YS-033-10

SUBJECT: 33" Gas Furnace 2 Stage Control Board Issues

PRODUCT: TM8V, TMLV & TM9V

Figure 1: Setting up Board for Comfort Profile

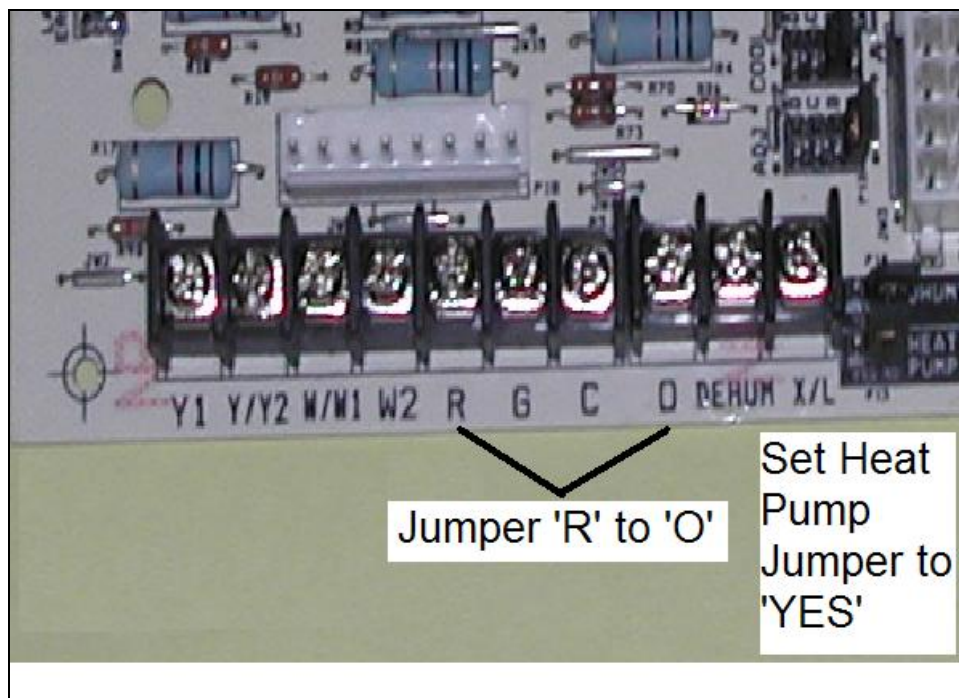
Recently, we have received field reports of the "Comfort Profile" feature not operating as expected. We have confirmed a "Hardware" issue exists with the control. It will take some time to fix the hardware issue, so a field fix has been created.

1. For the "Comfort Profile" feature implemented by the 'Delay' jumper, it is necessary to add a wire jumper from the 'R' terminal to the 'O' terminal and then set the 'Heat Pump' selection jumper to 'Yes', refer to Fig 1.

Figure 2: Setting up Board for Full Cooling CFM or Dehumidification Feature

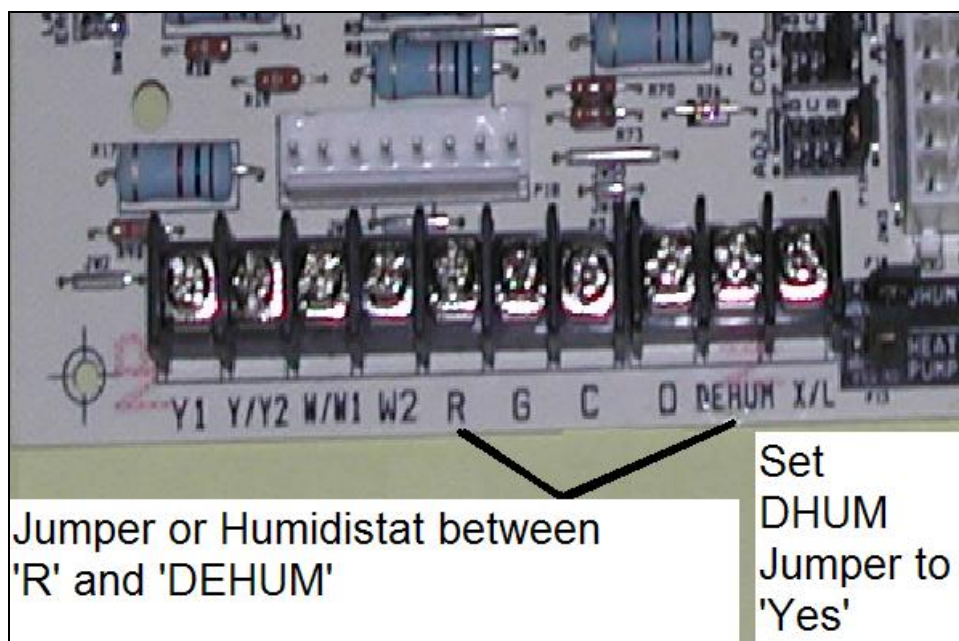
2. To achieve full programmed cooling CFM, it is necessary to add a wire jumper from the 'R' terminal to the 'DEHUM' terminal and set the 'DHUM' selection jumper to 'Yes', refer to Fig 2.

3. For the “Dehumidification” feature to be active, where the blower runs at 85% of the programmed speed in high humid conditions simply add a ‘Humidistat’ between ‘R’ and ‘DHUM’, instead of the wire jumper as described above, refer to Fig 2.
4. Moving the System Selection Jumper HEAT PUMP to ‘YES’ will have no effect on Cooling only systems.
